Re: St. Lucie Unit 2
Docket No. 50-389
Inservice Inspection Plan
RAI Reply - Third Ten-Year Interval Unit 2 Relief Request No. 14

**St. Lucie Unit 2
THIRD INSPECTION INTERVAL
RAI REPLY RELIEF REQUEST NUMBER 14, REVISION 0**

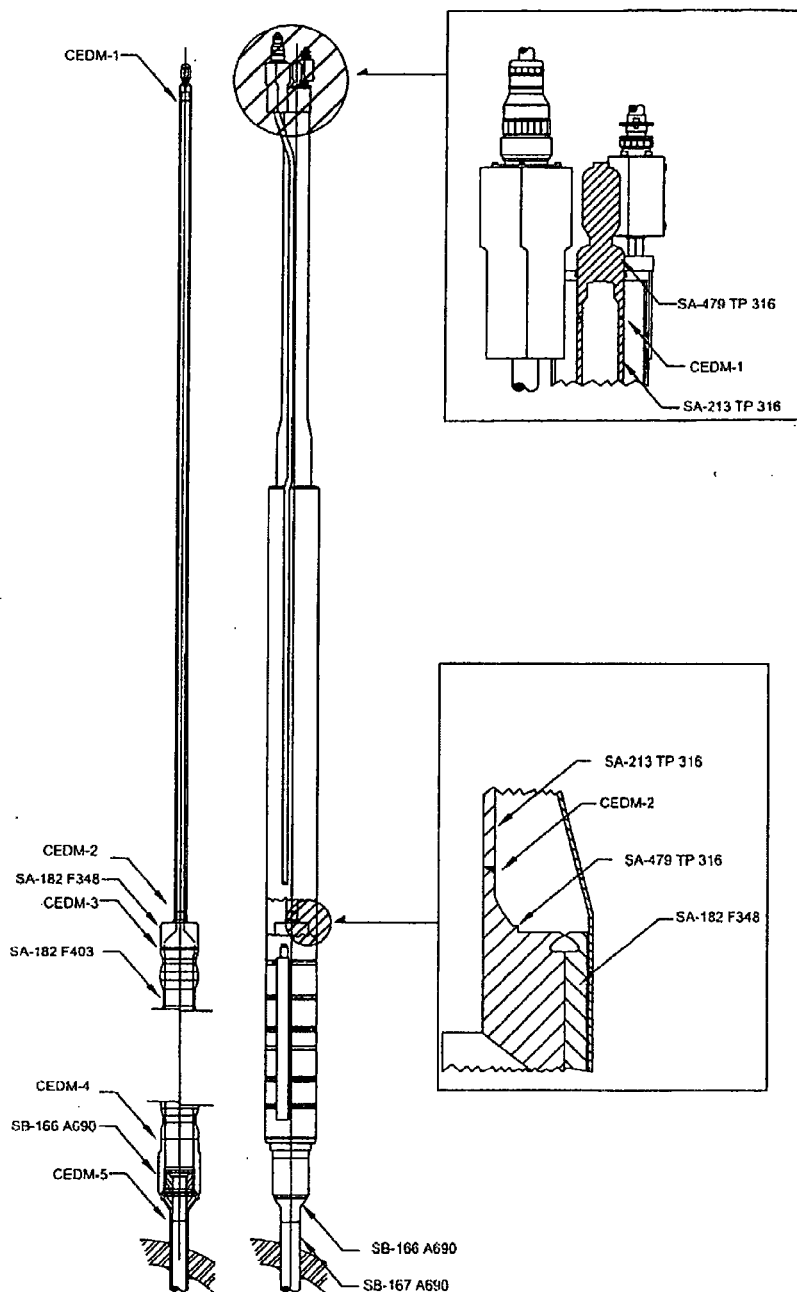
- (a) Page 3 of the relief request identified the two base metals that were joined with CEDM housing weld No. 1. However, the base metals for some welds were not clearly identified. Provide the material specification (e.g., SA-276 F403) of base metals that were joined with CEDM weld numbers 2, 3, 4 and 5. Provide the material specification of the filler metal used in each of the CEDM housing welds. Discuss the base metal and weld metal used that would minimize the potential for degradation.

The weld metal and the adjoining base metals for the CEDM welds are listed in the table below:

CEDM Weld #	Component /Spec	Component/Spec	Weld material	Comment
1	Upper Pressure Housing (UPH) Upper End Fitting, SA479-Tp316	UPH-Tube, SA-213 Tp316	IN316L & ER316L	GTAW process, Consumable insert & bare wire
2	UPH-Tube, SA-213 Tp316	UPH Lower End Fitting, SA479-Tp316	IN316L & ER316L	GTAW process, Consumable insert & bare wire
3	Motor Housing Upper End Fitting, SA182-F348	Motor Housing, SA182-F403 Mod with CC N-2	ERNiCrFe-7A (UNS N06054)	GTAW process, bare wire
4	Motor Housing, SA182-F403 Mod with CC N-2	Motor Housing Lower End Fitting, SB166-Alloy N06690	ERNiCrFe-7A (UNS N06054)	GTAW process, bare wire
5	Reactor Vessel Head Penetration Adapter, (SB166-Alloy N06690)	Reactor Vessel Head Penetration Tube, (SB167-Alloy N06690)	ERNiCrFe-7 (UNS N06052) or ENiCrFe-7 (UNS W86152)	GTAW process or SMAW process

The CEDM upper pressure housing sub-components and welds 1 and 2 are 316/316L austenitic stainless and are the same grade as previously used at St. Lucie Unit 2 without any service related degradation. The CEDM motor housing is similar to the original CEDM motor housing except the alloy 600 material and weld material has been replaced with alloy 690 and its compatible alloy 52/152 weld material which has superior resistance to PWSCC degradation.

The figure of the CEDM assembly has been revised below to show the location of each material.
